ZONING CHANGE REVIEW SHEET

CASE: C14-2023-0003 (E. 51st St. & Cameron Rd.)

From: Nathan Aubert, P.E.
To: Kathy Smith, P.E., PTOE
Date: June 23, 2023
Subject: 51st and Cameron – Zoning Transportation Analysis (C14-2023-0003)

Figure 2. Conceptual Site Driveways (Figure taken from ZTA report); Driveways A, B, C, D are for site access. Driveways 1-4 are service driveways.

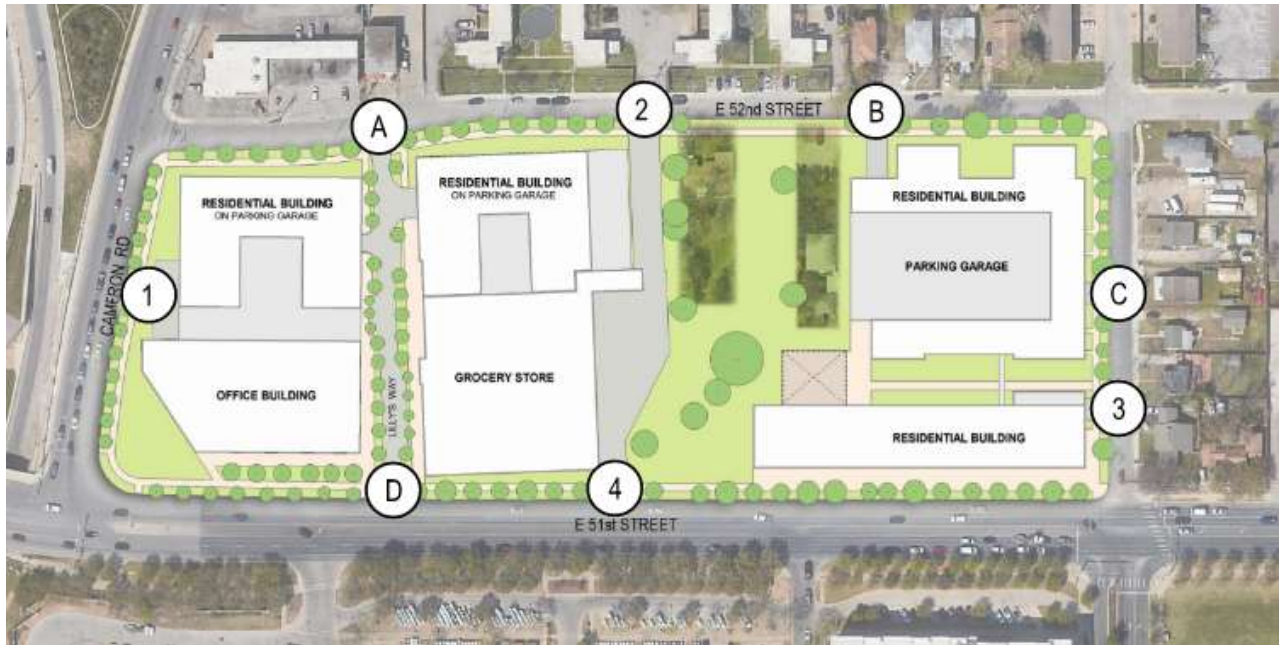
The site proposes four full purpose driveways on 52nd St (Driveways A, B), Lancaster Ct (Driveway C), and E 51st St (Driveway D). The site proposes four additional service driveway locations on (1) Cameron Rd, (2) 52nd St, (3) Lancaster Ct, and (4) E 51st St. A conceptual site plan showing proposed driveway locations can be seen in Figure 2.

1. Provide no more than one site and one service driveway on E 51st St (designated driveways D, 4). Both driveways are proposed to operate as full purpose and will be reviewed for compliance to City codes, ordinances, criteria manual, etc. at the time of the Site Plan application.

2. Provide no more than one service driveway onto Cameron Rd (designated driveway 1), provided it can meet design requirements and does not require a waiver from the Transportation Criteria Manual (TCM). The driveway is proposed to operate as full purpose and will be reviewed for compliance to City codes and ordinances at the time of the Site Plan application.

3. Provide no more than two site and one service driveways on E 52nd St (designated driveways A, B, 2). The driveways are proposed to operate as full purpose and will be reviewed for compliance to City codes and ordinances at the time of the Site Plan application.

4. Provide no more than one service driveways on Lancaster Ct (designated driveways C,3). The driveway is proposed to operate as full purpose and will be reviewed for compliance to City codes and ordinances at the time of the Site Plan application.
